**Project: IEEE P802.15 Working Group for Wireless Personal Area Networks (WPANs)**

**Submission Title:** [Resolution for Multiple PHYs]

**Date Submitted:** [ 13 May, 2008]

## Comments Resolution for Interoperability among the Three PHYs in DF3

## Comments on Interoperability

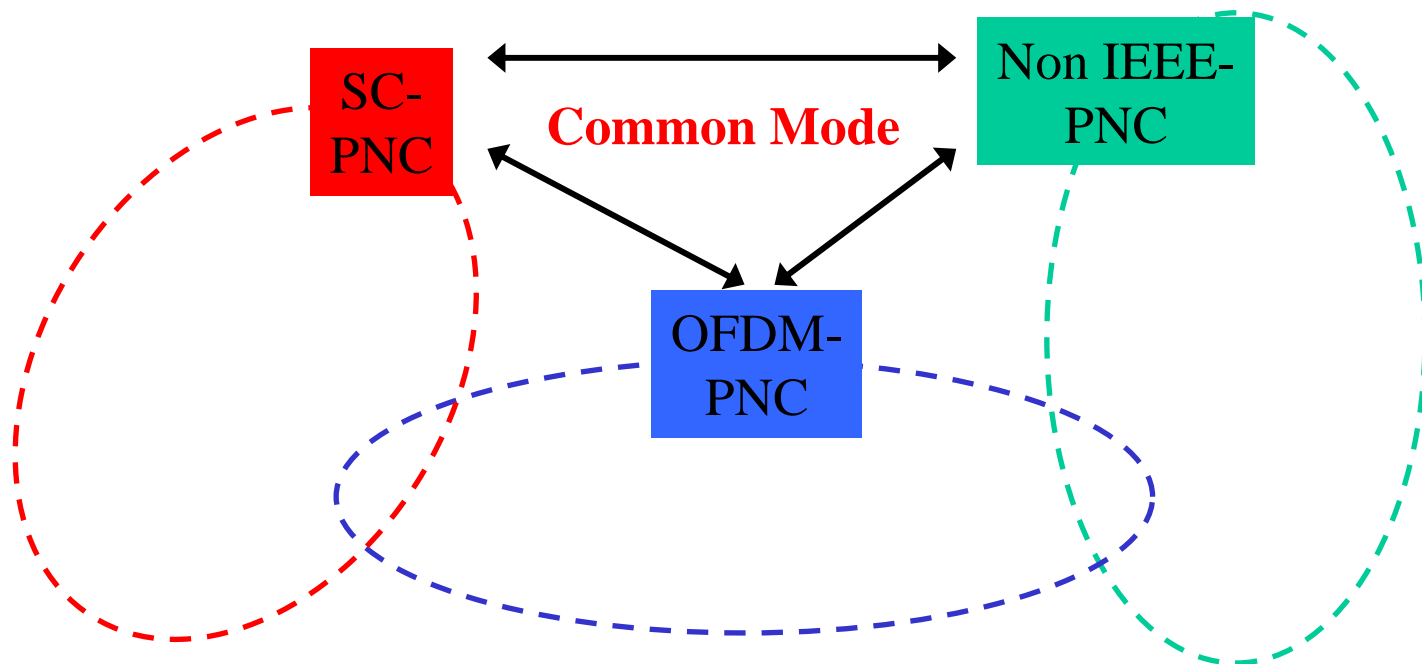
- Comments #16, #30, #80, #97, #115  
(in 15-08-0255-02-003c-df3-issue-tracking)
  - : The optional MMC is not sufficient for interoperability
  - : A mandatory mechanism is needed for efficient interoperability among multiple PHYs

- Mandating the SC common rate as the common transmission mode (Common Mode) for all PNC-capable devices to ensure efficient interoperability and/or piconet-coexistence
  - OFDM PNC-capable devices should transmit both OFDM and SC beacons in a superframe
  - OFDM PNC-capable devices should be able to receive the SC common rate
